**Addendum to Noise Impact Assessment**

Our Ref: 4158C\_R11\_SRQ\_NIA\_Addendum\_Letter\_Final

## **RE: Stone Ridge Quarry Addendum – NIA**

**APPENDIX A**  
**Conceptual Quarry Plans**

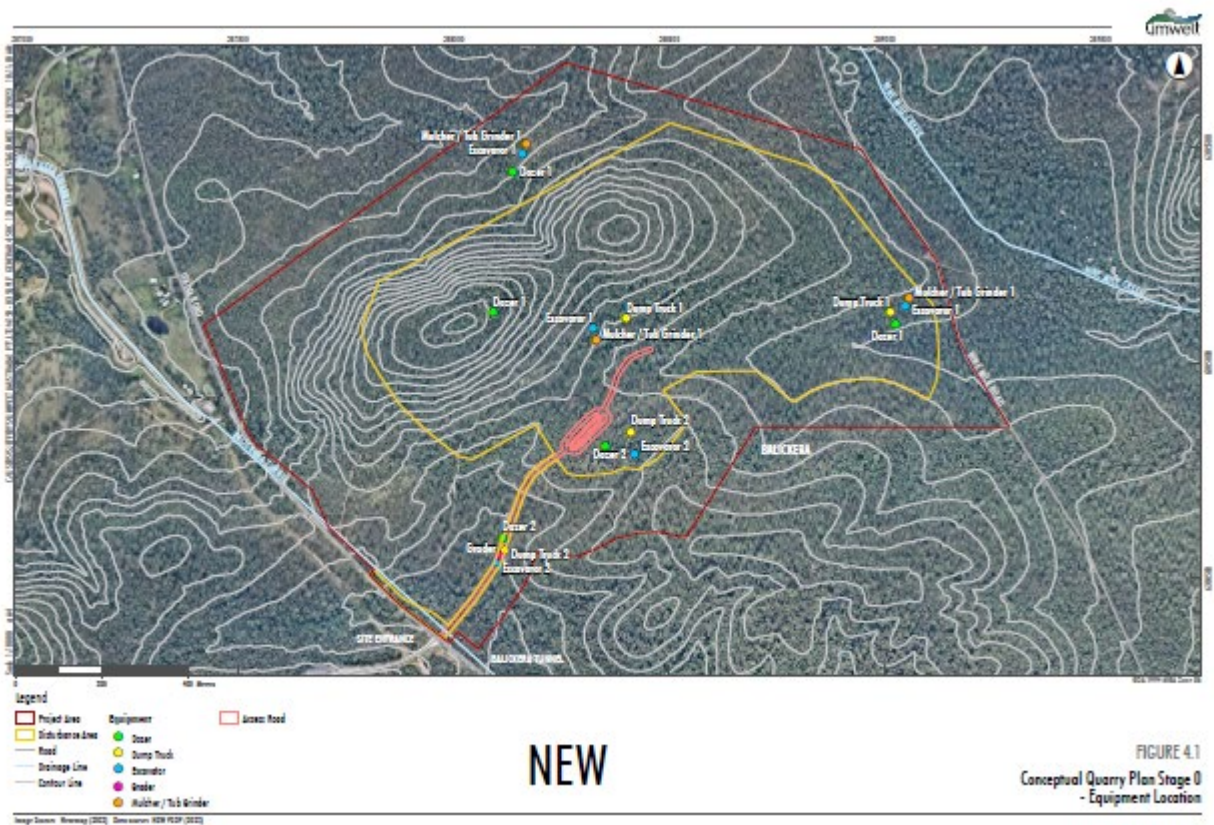
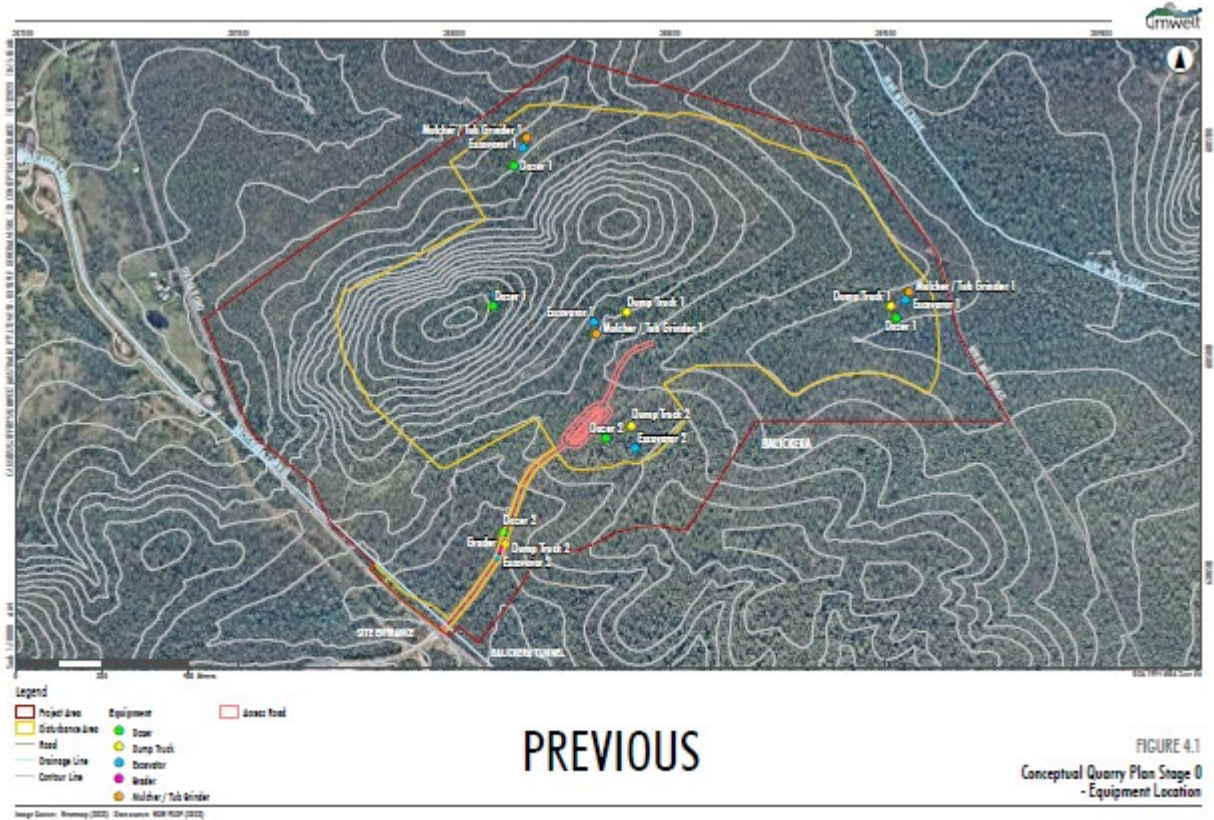
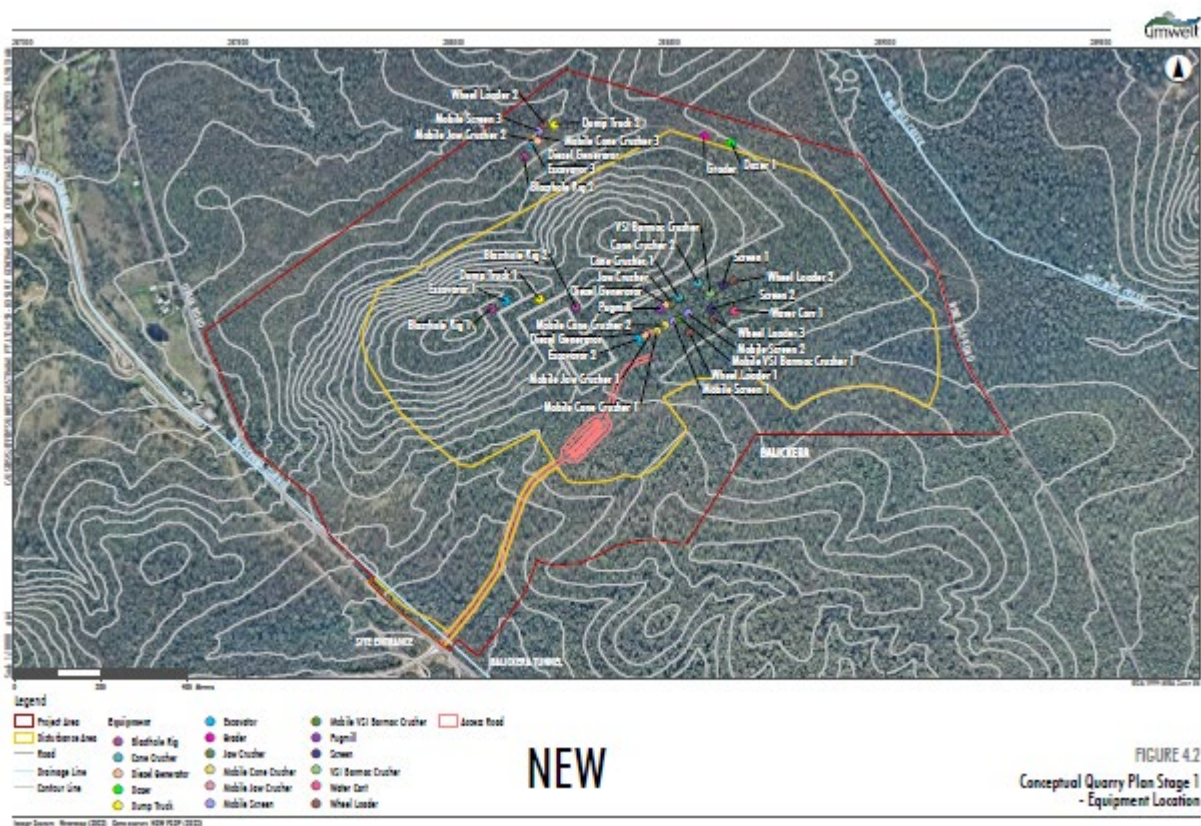
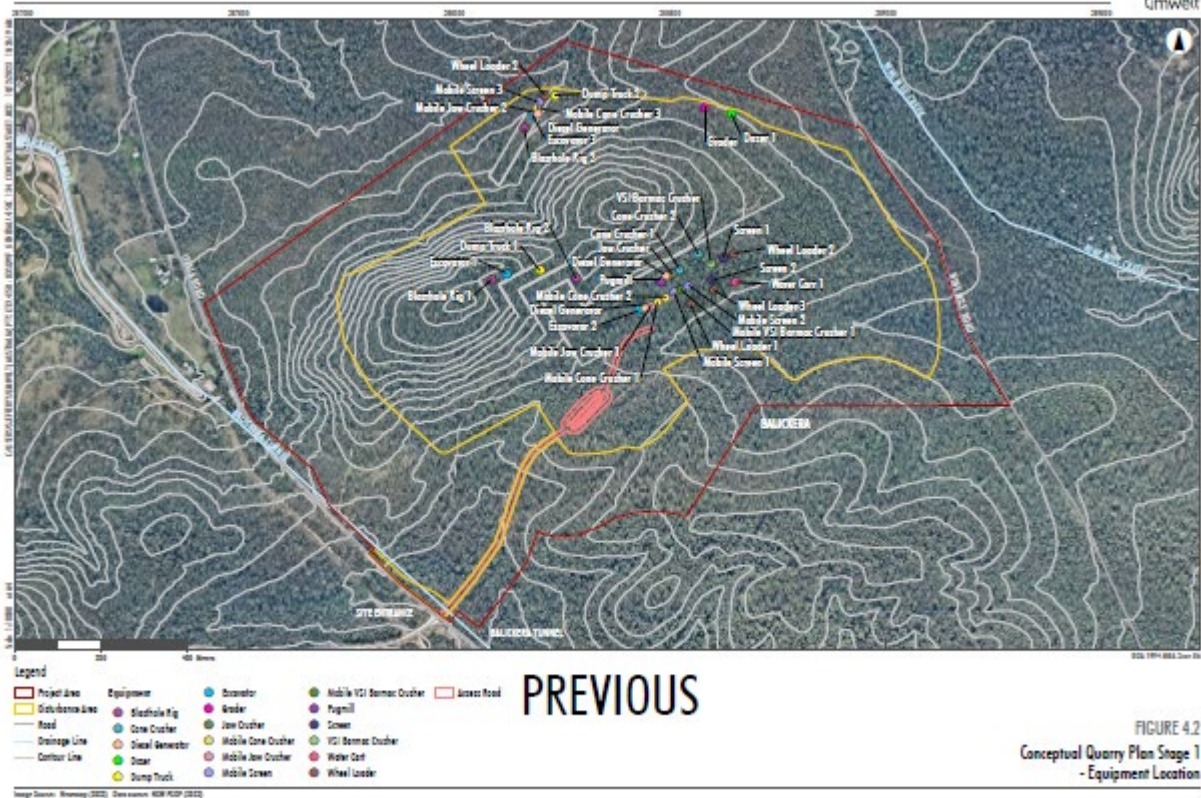
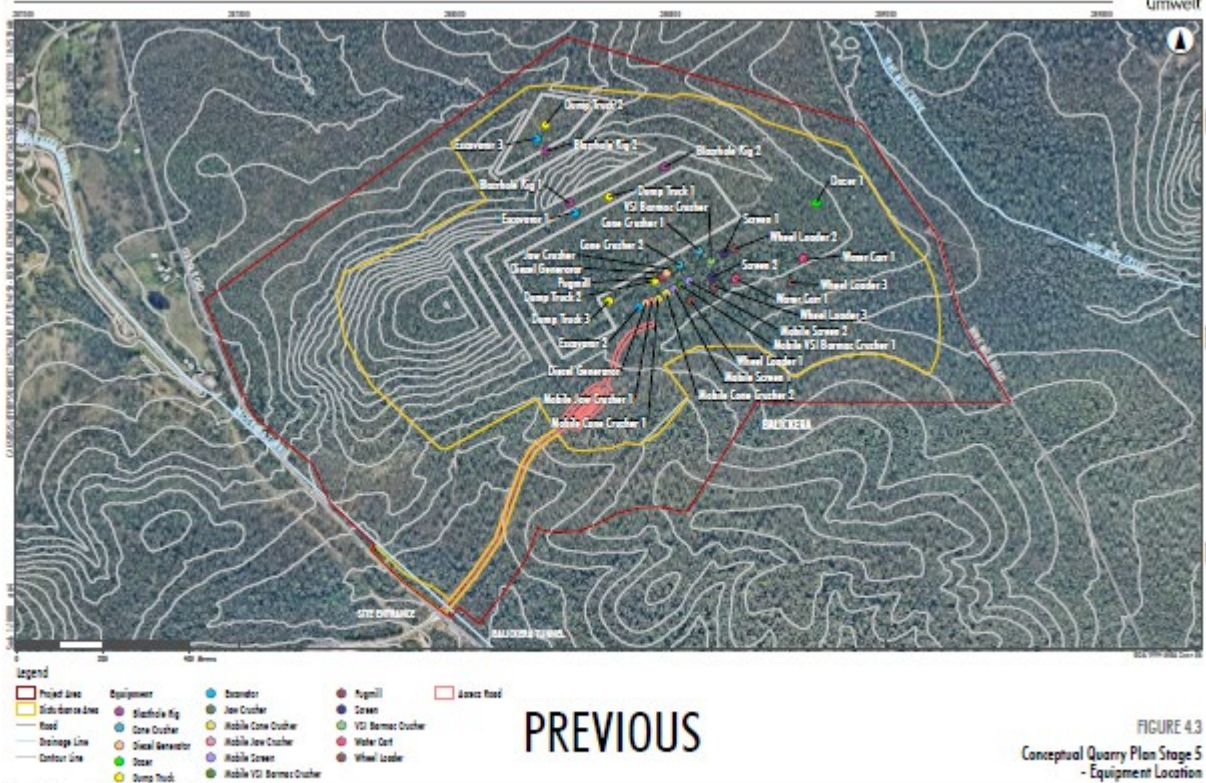
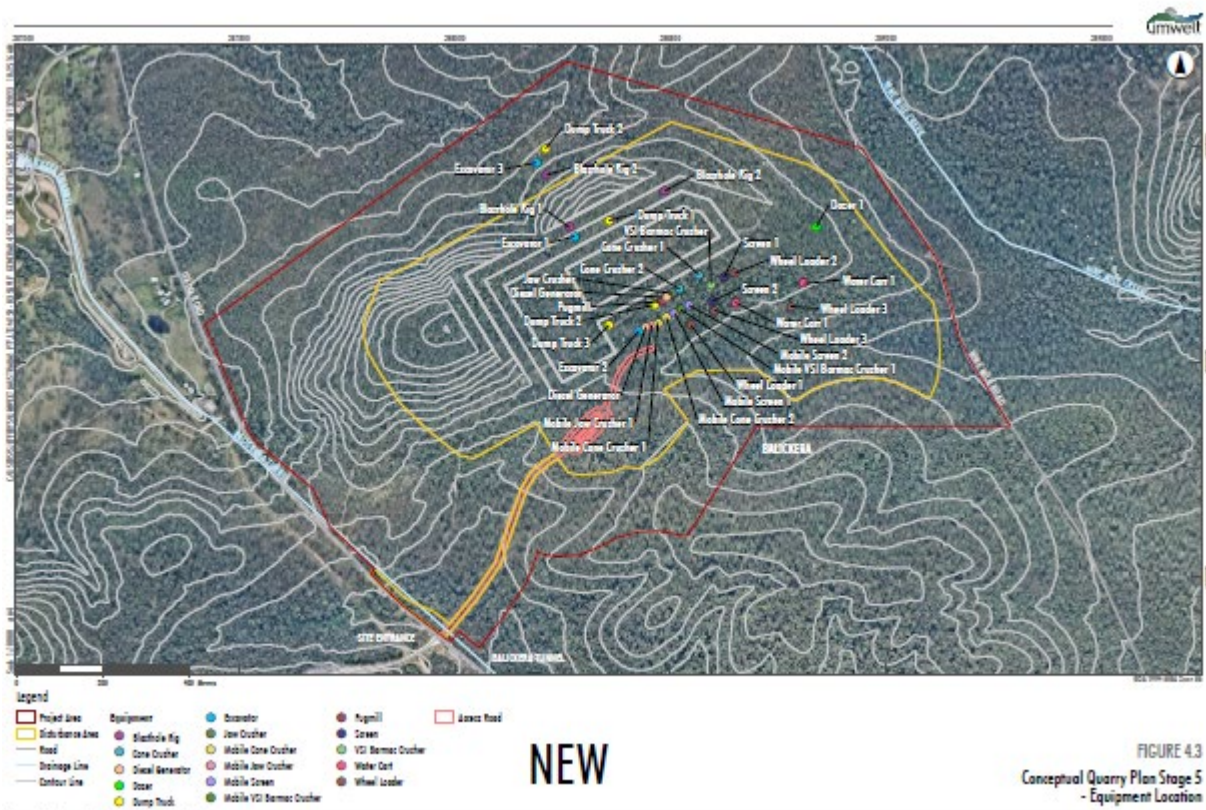
The conceptual quarry layout has been refined to remove the North Pit, associated sediment basin 2 and access roads, while also revising the stage plans associated with the Main Pit. The proposed amendment would result in a reduction in the overall Project disturbance footprint from 79.02 ha to 68.09 ha, a reduction of 10.93 ha (14 %), while optimising extraction of available resources from within this reduced footprint. The proposed amendment does not propose any change to the total resource extraction or any other aspect of the Project.

For comparison, the quarry plans for Stage 0, 1, 5 and 9 of the EIS and proposed amendment are shown in **Appendix A**.
